SERVICE BULLETIN – MOSTER185

Safety conditions and devices of the MY19 Airbox

1P04-0017_02 - AIRBOX SAFETY STRIP UPDATE

1P04-0017_02 - AIRBOX INSTALLATION - 1/2

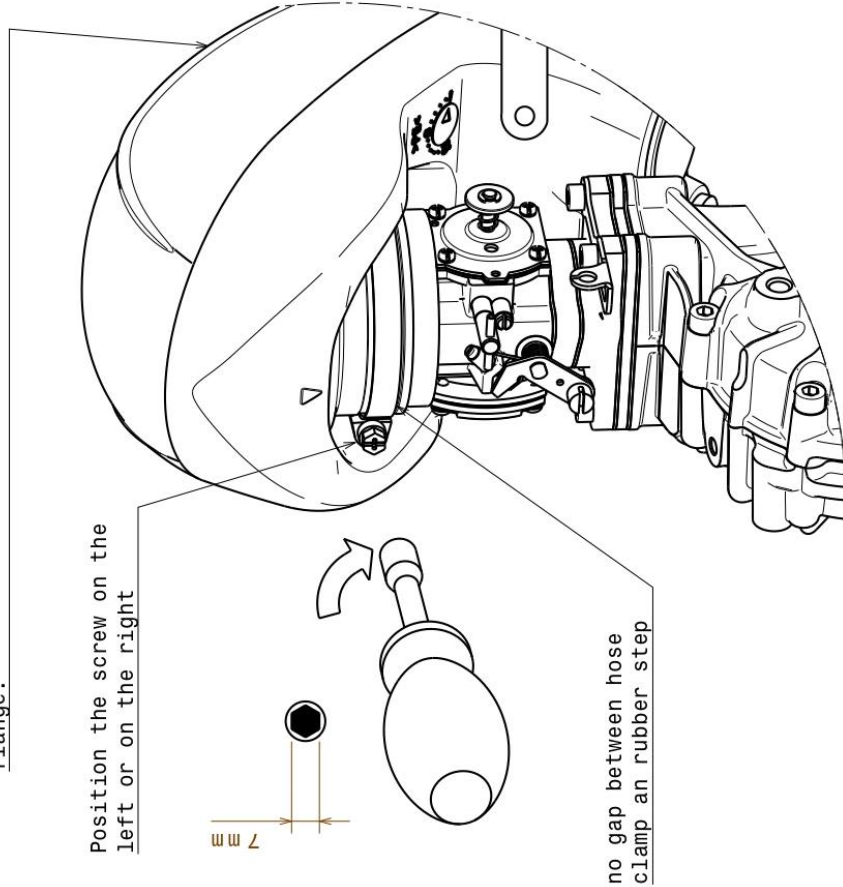
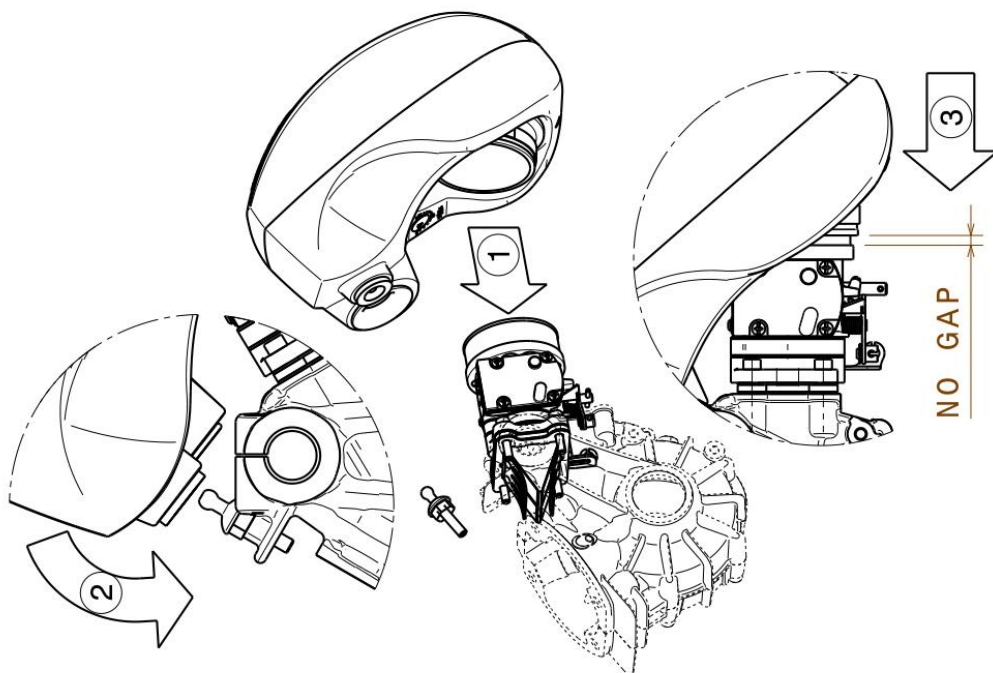
1. Check alignment before tightening the hose clamp
2. Verify installation:
Push/Pull the airbox. There must be no relative motion between rubber sleeve and carburetor inlet flange.

Tighten the hose clamp carefully:

1. use hexagonal screwdriver
2. apply 2,5 Nm torque
3. if you don't have a torque wrench
 - 3.1 tighten the hose clamp until it start squeezing the rubber
 - 3.2 apply 1 and $\frac{1}{2}$ more complete turns

1P04-0017_02 - AIRBOX INSTALLATION - 2/2

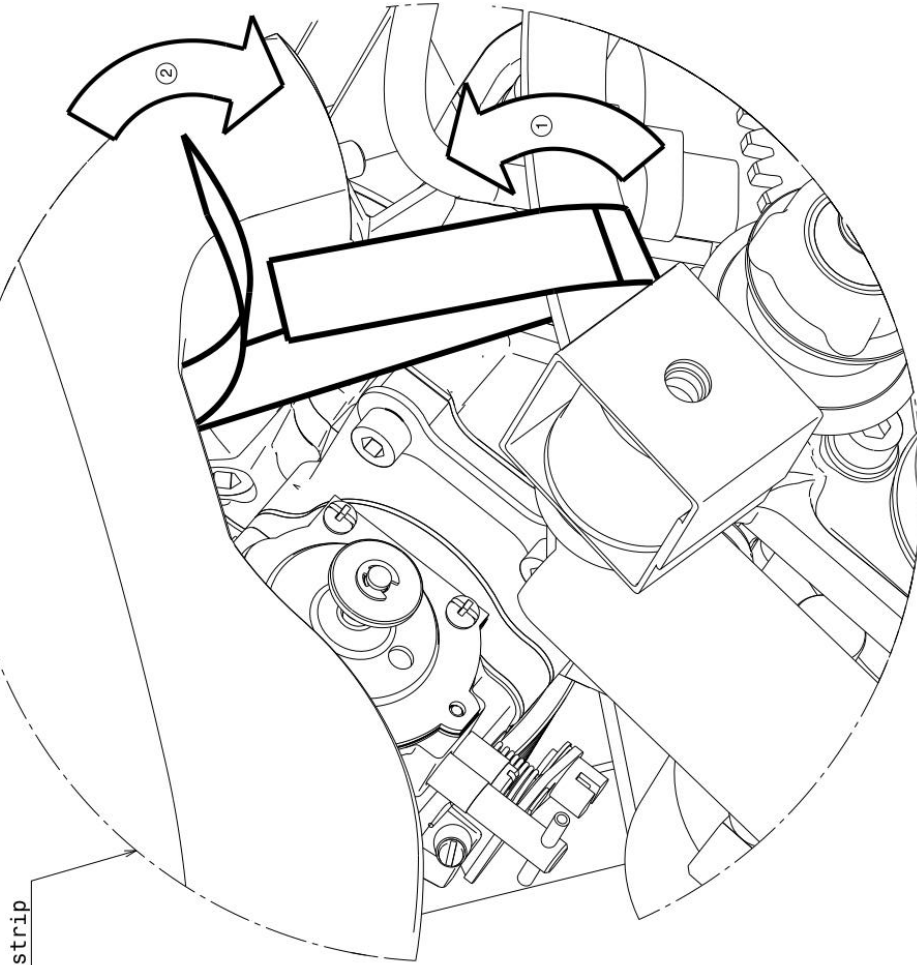
Apply safety strip

- 1.a Position the safety strip on the aluminium frame between the coil and the silentblock
- 1.b Make sure that the strip is not loose
2. Close the second velcro strip
3. On engines with electric motor turn the throttle cable outward.
